APPLICATION NO.	F	ILING DATE	FIRST NAMED INVENTOR	ATTORNEY DOCKET NO.	CONFIRMATION NO.	
10/668,481	181 09/22/2003		Peter Oberhans	10901/52	2928	
26646	7590	06/21/2006		EXAMINER		
KENYON ONE BROA		ON LLP	LAU, TUNG S			
NEW YOR		0004		ART UNIT	PAPER NUMBER	
				2863	2863	
				DATE MAILED: 06/21/2006	DATE MAILED: 06/21/2006

Application No.	Applicant(s)	
	10/668,481	OBERHANS ET AL.	
Office Action Summary	Examiner	Art Unit	
	Tung S. Lau	2863	
The MAILING DATE of this communication ap Period for Reply	· ·	e correspondence address	
A SHORTENED STATUTORY PERIOD FOR REPL WHICHEVER IS LONGER, FROM THE MAILING E - Extensions of time may be available under the provisions of 37 CFR 1. after SIX (6) MONTHS from the mailing date of this communication. - If NO period for reply is specified above, the maximum statutory period - Failure to reply within the set or extended period for reply will, by statut Any reply received by the Office later than three months after the mailing earned patent term adjustment. See 37 CFR 1.704(b).	DATE OF THIS COMMUNICATI 136(a). In no event, however, may a reply be will apply and will expire SIX (6) MONTHS for the, cause the application to become ABANDO	ON. e timely

FIG. I

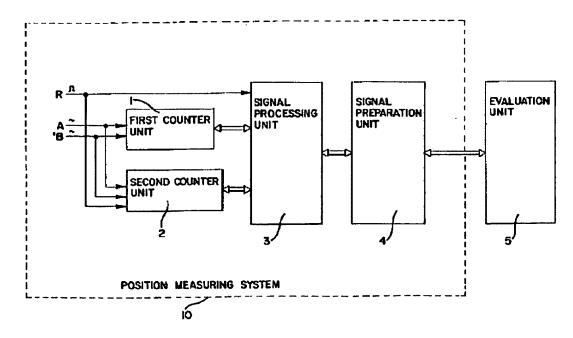
Hagl discloses a method for correcting position dependent scanning signals of an incremental position transducer for measuring position (fig. 1,

unit 1, 2), the position dependent scanning signals (fig. 1, unit 1, 2) having deviations from ideal signals expected by a downstream evaluation unit (abstract), comprising: feeding the position dependent scanning signals of the incremental position transducer to a correction unit in response to a signal request (fig. 1, unit 5, Col. 4-5, Lines 57-19); the incremental position transducer including a periodic scale structure scanned by a scanning unit (Col. 1-2, Lines 55-3); linking the position dependent scanning signals in the correction unit to correction data generated in accordance with active values of the scanning signals (fig. 1, unit 1, 2, 3, 4); and exclusively feeding scanning signals for generating correction data to the correction unit for at least one predefined time segment of finite length (fig. 5, unit 50) following each request of new scanning signals to be corrected (Col. 4-5, Lines 57-19, Col. 5-6, Lines 65-11).

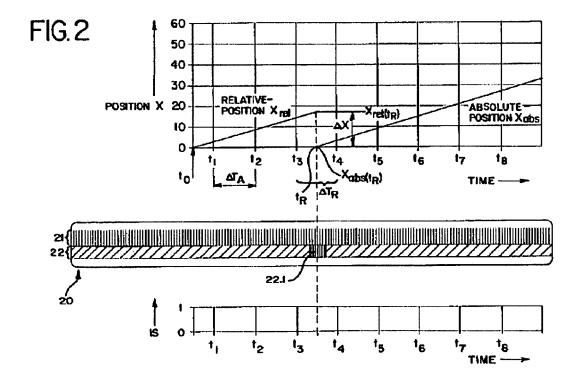
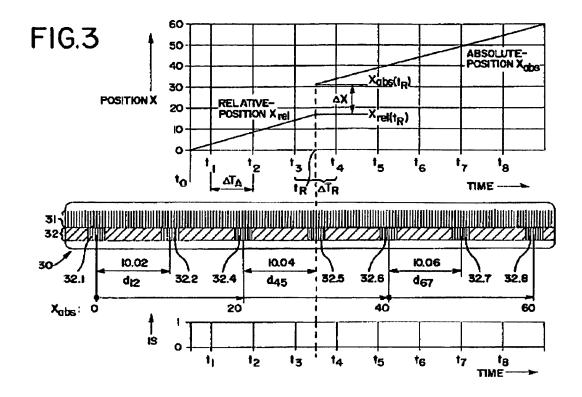
scanning signals (fig. 3, unit 30); and exclusively feeding scanning signals for generating correction data to the correction unit for at least one predefined time segment of finite length (fig. 3) following each request of new scanning signals to be corrected (Col. 4-5, Lines 57-19); and Checking the signal requested by a logic device to determine whether the signal request applies to scanning signals that are to undergo a correction in the correction unit or to scanning signals for generating correction data (Col. 4-5, Lines 57-19, Col. 5-6, Lines 66-11).

dependent signals in the correction unit to correction data generated in accordance with active values of the scanning signals (fig. 1, unit 5); and exclusively feeding scanning signals for generating data to the correction unit for at least one predefined time segment of finite length (fig. 5, unit 50) following each request of new scanning signals to be corrected (Col. 4-5, Lines 57-19, fig. 3, 5).
